# UNITED STATES PATENT AND TRADEMARK OFFICE

APPLICATION NO.	FILING DATE	FIRST NAMED INVENTOR	ATTORNEY DOCKET NO.	CONFIRMATION NO.
10/699,152	10/31/2003	Flabio Cavalheiro		1479
7590	05/09/2005		EXAMINER	
Stephen E. Feldman Suite 701 12 East 41st. New York, NY 10017			BALSIS, SHAY L	
			ART UNIT	PAPER NUMBER
			1744

<b>Office Action Summary</b>	Application No.	Applicant(s)
	10/699,152	CAVALHEIRO, FLABIO
	Examiner Shay L. Balsis	Art Unit 1744

## **DETAILED ACTION**

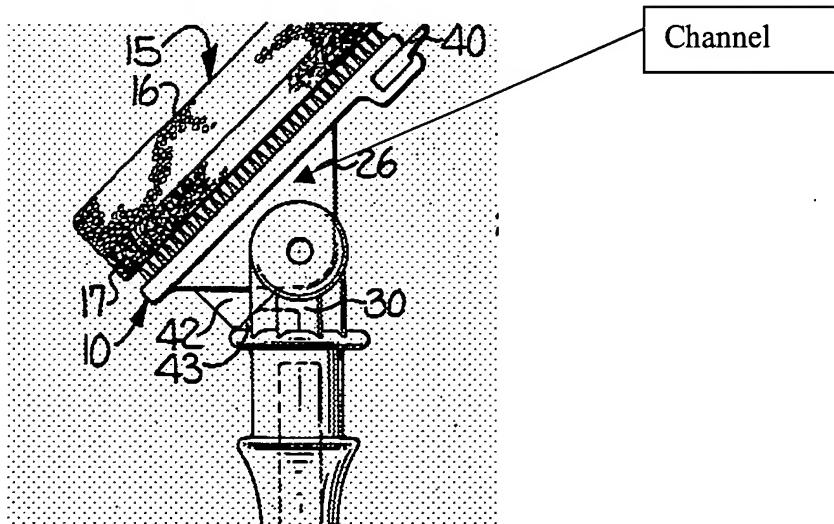
Graham teaches a cleaning device comprising a cleaning member (figure 1, element 15) with a first surface having a scouring surface of loop material (figure 1, element 17) (claims 1 and 8) and a second surface comprising a sponge (figure 1, element 16) (claim 10). There is a base plate (figure 1, element 10) having a plurality of projections (figure 1, element 20) arranged in rows and columns for gripping the first surface of the cleaning member (claim 1, 6). The projections each have a top segment having opposing ends (figure 6, element 21) and an

intermediate section separating the top segment from the base plate by a predefined distance (claim 2). The opposing ends of the projections each have free ends, which terminate at substantially a point, and therefore the opposing ends have a cross section that is thicker at the connection of said ends to the top segment than at said free ends (figure 7) (claims 2, 3, 4). The intermediate section having bottom end defined by the connection of the intermediate section to the base plate and a top end defined by the connection of the intermediate section to the top segment, wherein the cross section is thicker at the bottom end than at the top end (figures 6 and 7) (claim 3). The distance between the end of each free end is *substantially* the same as the distance between the top end and the bottom end of the intermediate segment (figure 7) (claim 5). The base plate comprises a handle member (figure 1, element 25) including a grasping means that is curved throughout and configured to closely conform to the curvature of the inside of a user's hand and the grasping means is removable from the base plate (figure 5). The handle has a channel formed between a bottom surface of the handle and the base plate. The channel is configured in such a manner as to accept at least part of a user's finger when the handle is grasped (see figure below) (claim 1).

Applicant's arguments filed 4/8/05 have been fully considered but they are not persuasive. Graham's cleaning device may be held in such a manner that a portion of the user's finger (tip) may fit within the channel as shown in the above figure. Paepke clearly teaches a channel for receiving a portion of the finger as stated in col. 3, lines 12-19 and as shown in figure

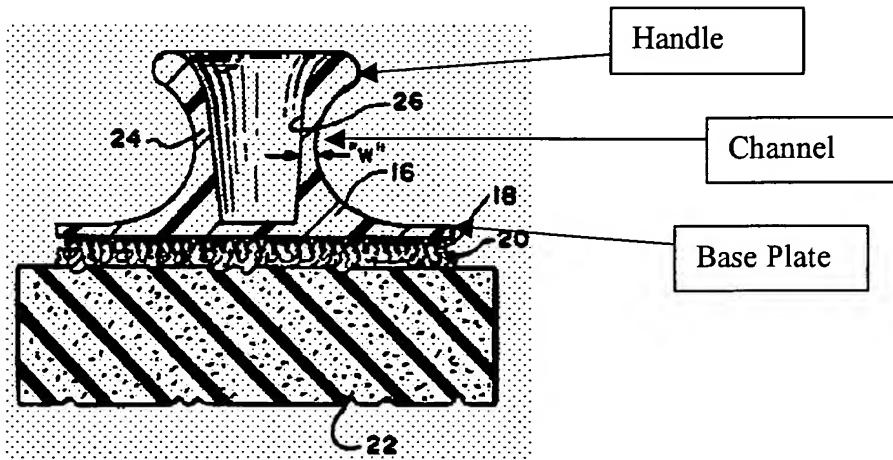
Paepke teaches a cleaning device comprising a cleaning member (figure 4, element 22) with a first surface having a scouring surface of loops material (figure 4, element 20) (claims 1a and 8) and a second surface comprising a sponge (figure 4, element 22) (claim 10). There is a base plate (figure 4, element 16) having a plurality of projections (figure 4, element 18) arranged in rows and columns for gripping the first surface of the cleaning member (claims 1 and 6). The base plate comprises a handle member (figure 2, element 12) including a grasping means that is curved throughout and configured to closely conform to the curvature of the inside of a user's hand and the grasping means is integral with the base plate. The handle has a channel formed between a bottom surface of the handle and the base plate. The channel is configured in such a manner as to accept at least part of a user's finger when the handle is grasped (figure 8, element R) (col. 3, lines 12-19) (claim 1) (see figure below). Paepke teaches all the essential elements of the claimed invention however fails to teach the exact style of hook/projection is used. Lacey teaches fastening hooks that each have a top segment having opposing ends (figure 18, element 402) and an intermediate section (figure 18, element 404) separating the top segment from the base plate by a predefined distance. The opposing ends of the projections each have free ends,

which terminate at substantially a point (figure 1, element 406), and therefore the opposing ends have a cross section that is thicker at the connection of said ends to the top segment than at said free ends (figure 18). The intermediate section having bottom end defined by the connection of the intermediate section to the base plate and a top end defined by the connection of the intermediate section to the top segment, wherein the cross section is thicker at the bottom end than at the top end (figure 18). The distance between the end of each free end is *substantially* the same as the distance between the top end and the bottom end of the intermediate segment (figure 18). It would have been obvious to one of ordinary skill in the art at the time the invention was made to use the hooks as taught by Lacey as the fastening means on Paepke since the hooks of Lacey have increased loop-engaging and loop-retaining characteristics which leads to better fastener performance (paragraphs [0144-0147]). Additionally, the hooks as taught by Paepke and the hooks as taught by Lacey are equivalent structures known in the art. Therefore, because these two fastening means were art-recognized equivalents at the time the invention was made, one of ordinary skill in the art would have found it obvious to substitute the hooks of Lacey for the hooks of Paepke.
